SUBMITTER No.	1840	ISSUE REFERENCE:	9109
SUBMITTER TYPE	Council	TOR CATEGORY	Social / Waste / Land
NAME	Barcaldine Regional Council	RELEVANT EIS SECTION	1.1.4

SUBMITTER No.	1840	ISSUE REFERENCE:	12021
SUBMITTER TYPE	Council	TOR CATEGORY	Air Quality / Land
NAME	Barcaldine Regional Council	RELEVANT EIS SECTION	Air Quality, Vol 2 Chapter 10

SUBMITTER No.	419	ISSUE REFERENCE:	4001
SUBMITTER TYPE	Government	TOR CATEGORY	Land (Land Contamination)
NAME	DERM	RELEVANT EIS SECTION	Volume 2, Mine – Section 3.4.6.2 (p131)

Figure 18. Rail Infrastructure Crossing (Sheet 4 of 5)

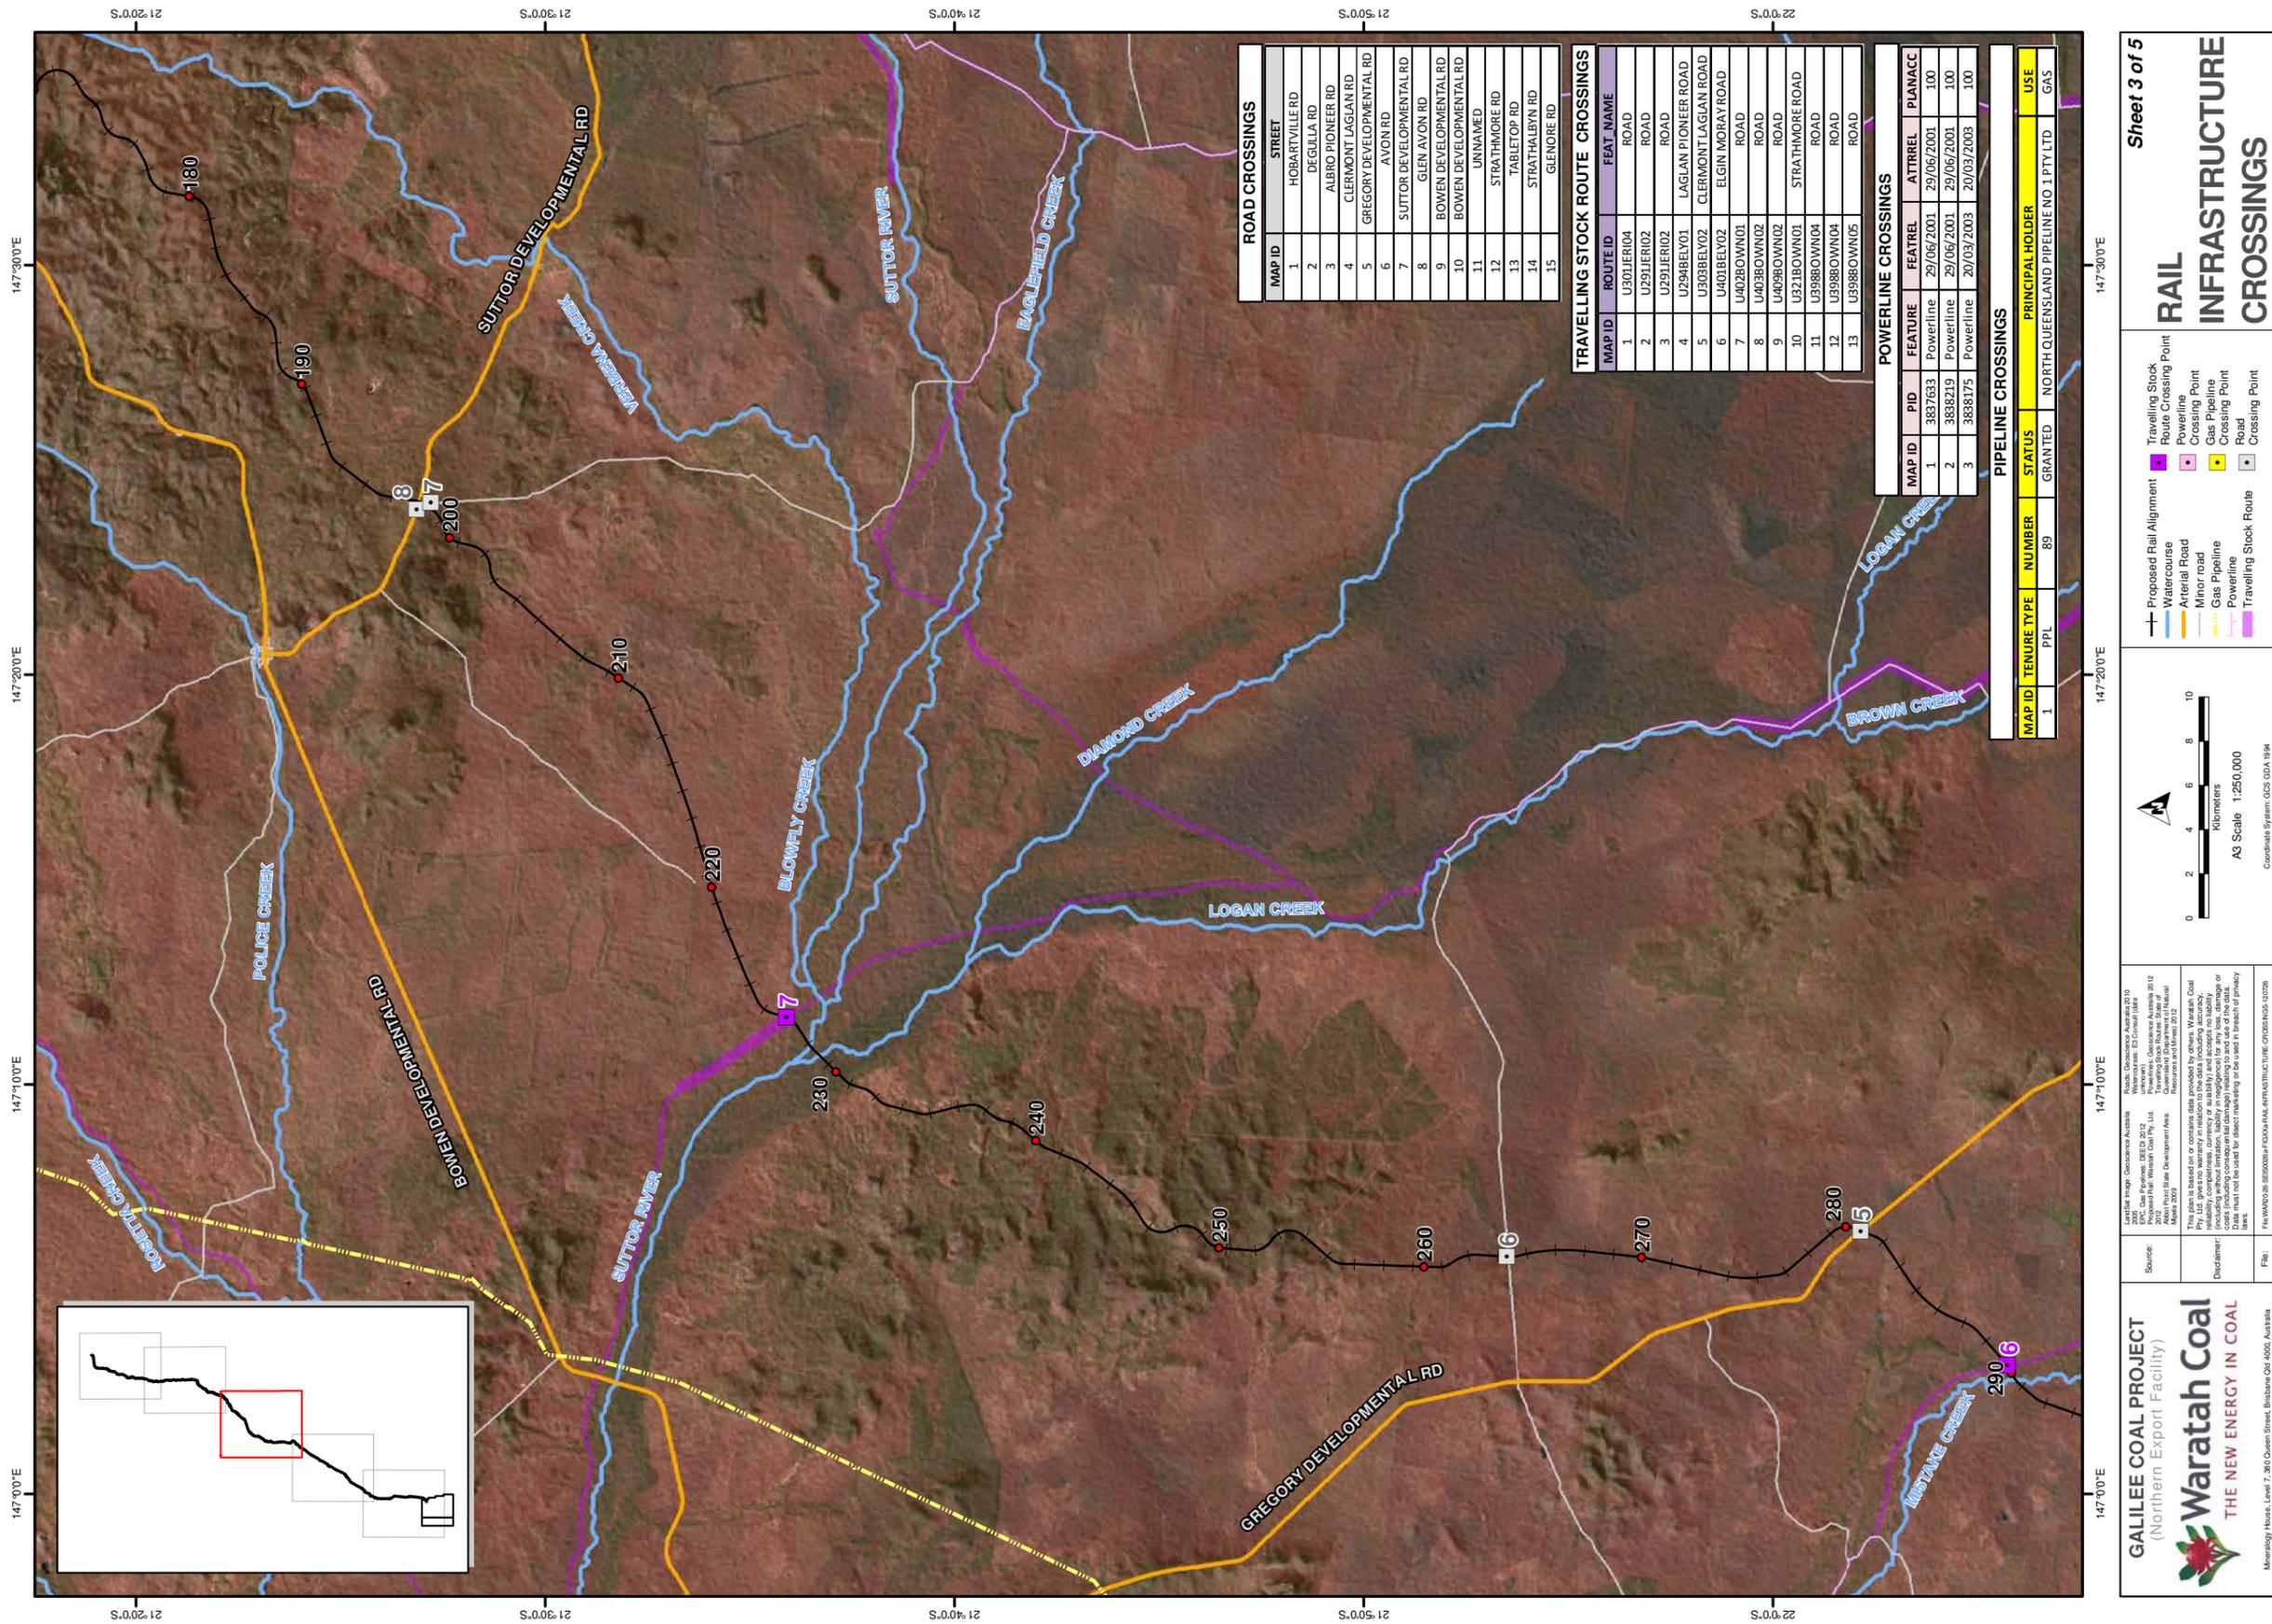
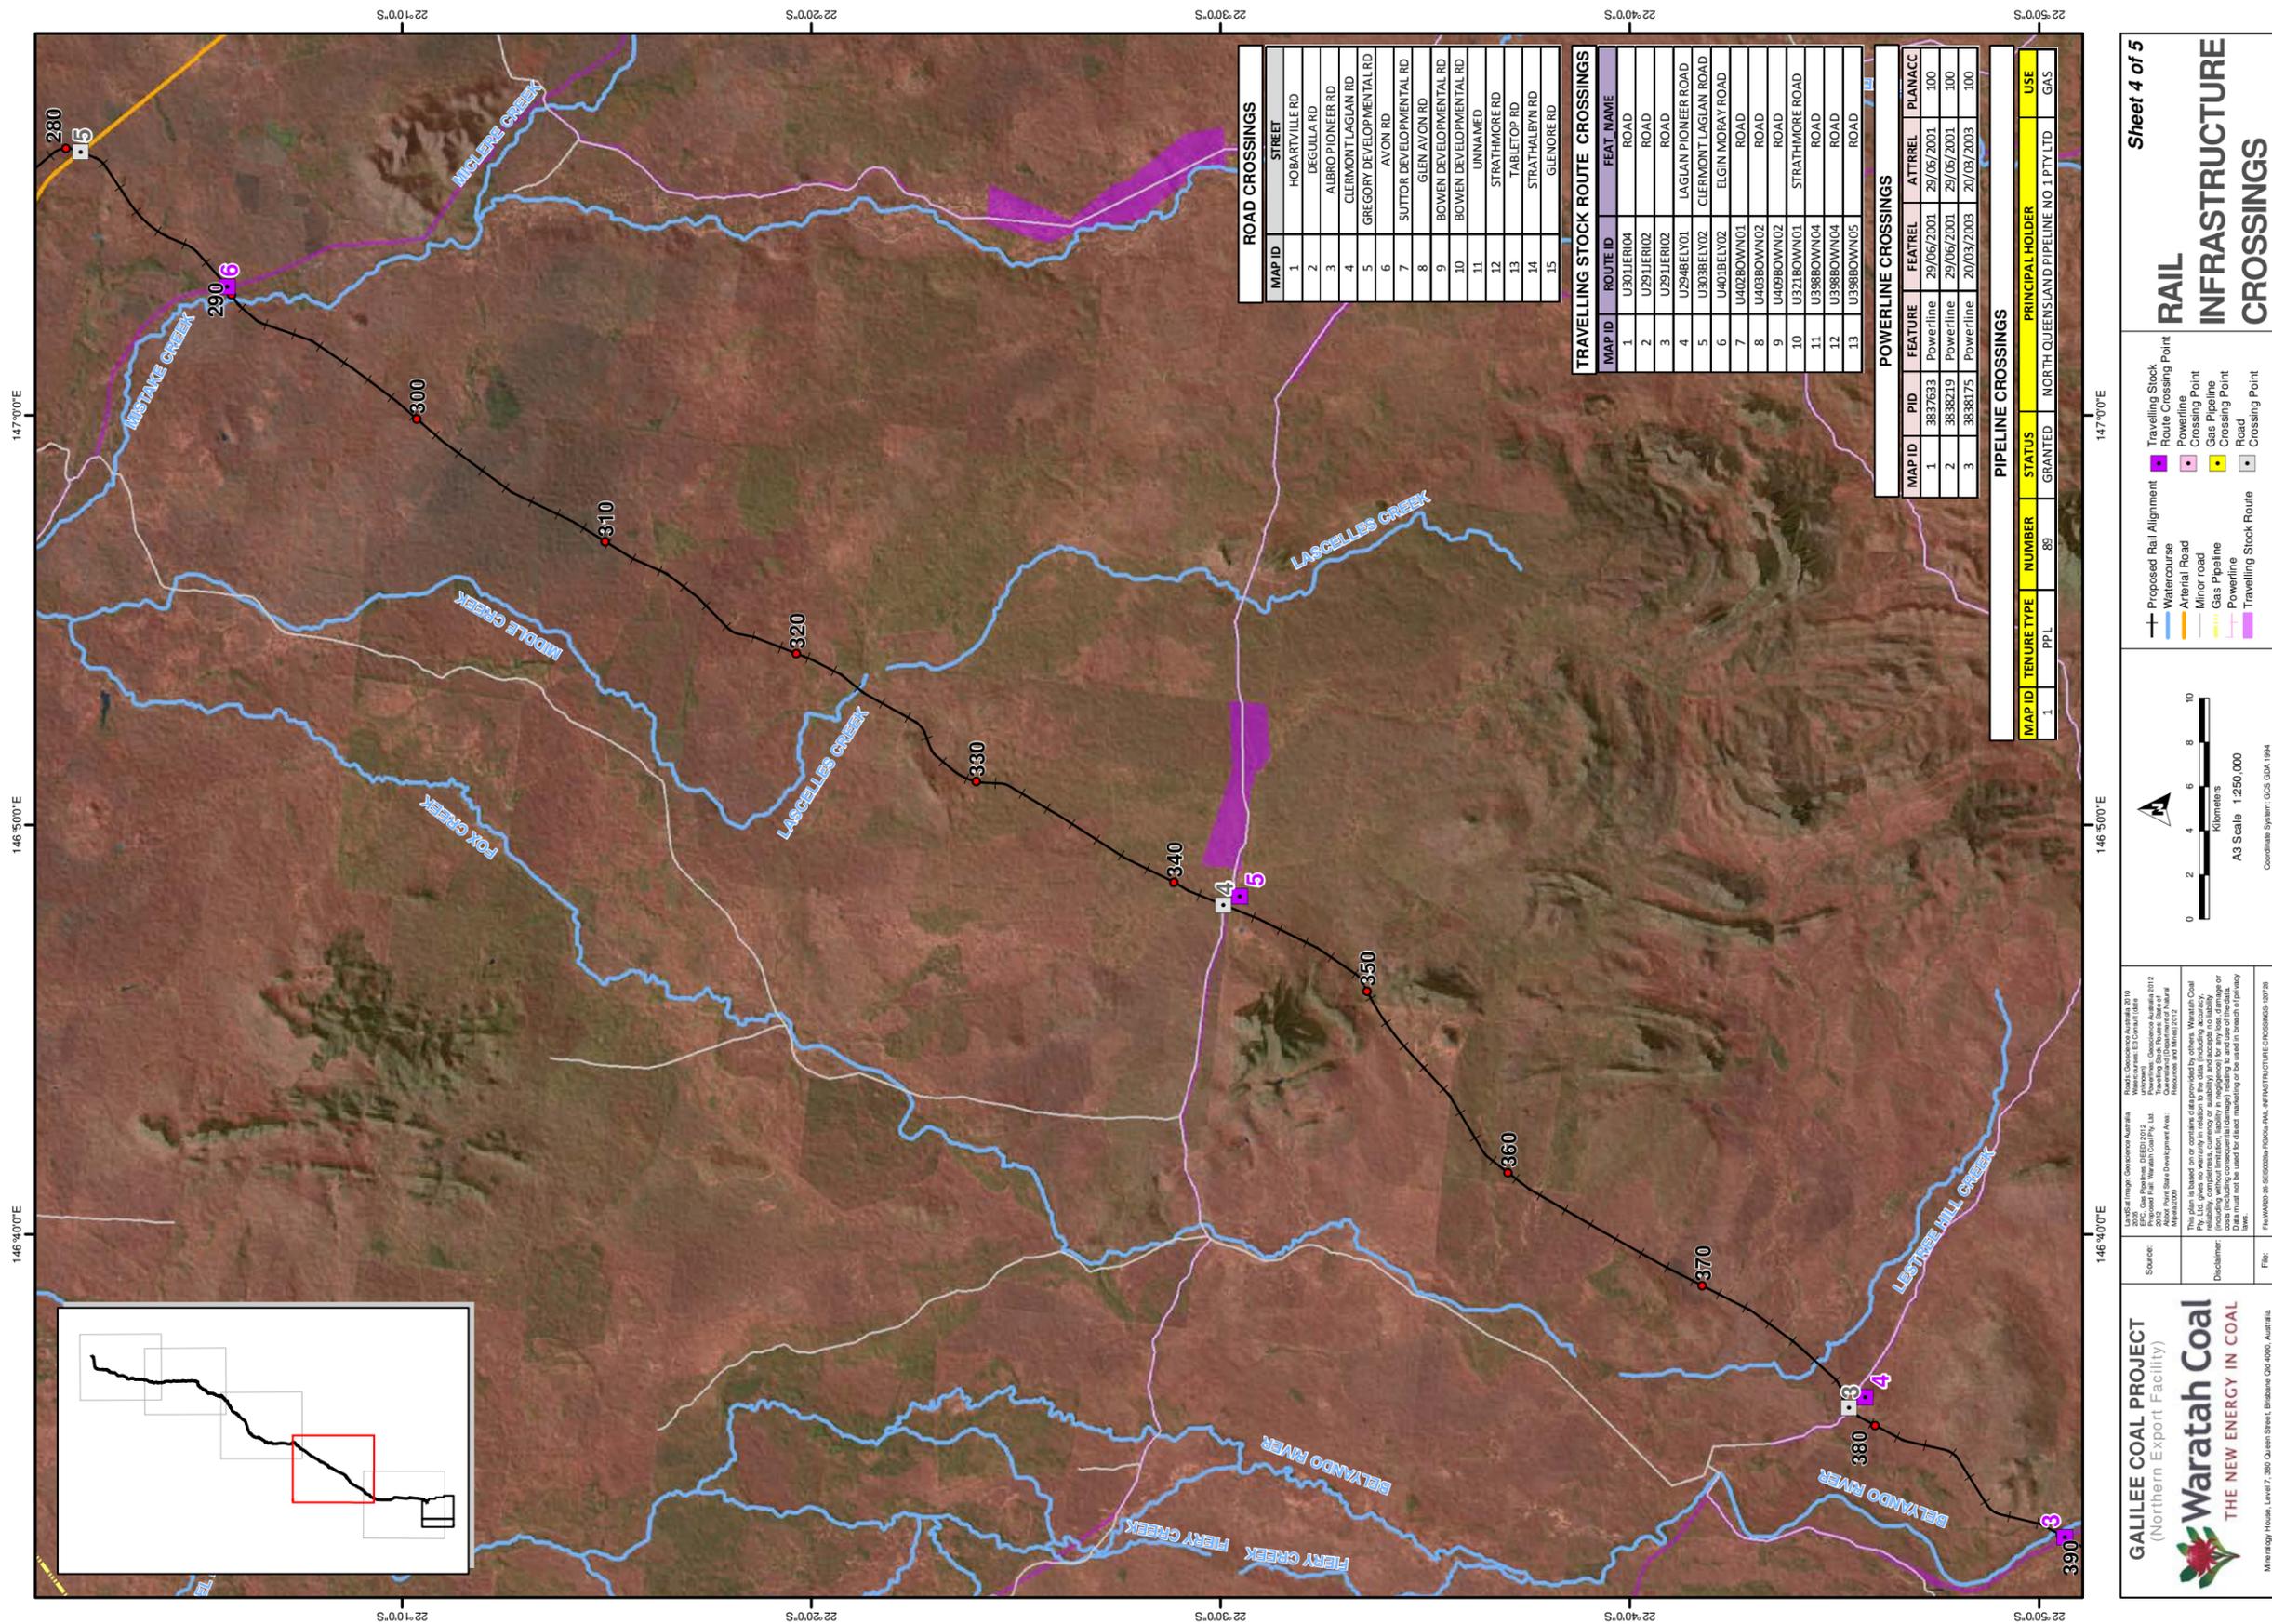
The EIS should detail how travelling stock can be moved from one side of the rail corridor to the other and thereby maintain the utility and connectivity of the stock route network.

The stock routes within the project region have been identified and are shown Figure 18. Where the Waratah Coal rail line traverses across an existing stock route, an undertrack crossing for the stock will be provided that limits the amount of ‘tunnel effect’ to a similar standard to those recently constructed for new rail projects within central Queensland and provides a safe and effective path for the stock and stockmen.

Where the rail alignment cuts across the same stock route in several places within a relatively short distance, there may be an opportunity to realign the stock route along one side of the rail only, to provide a shorter and more effective stock route.
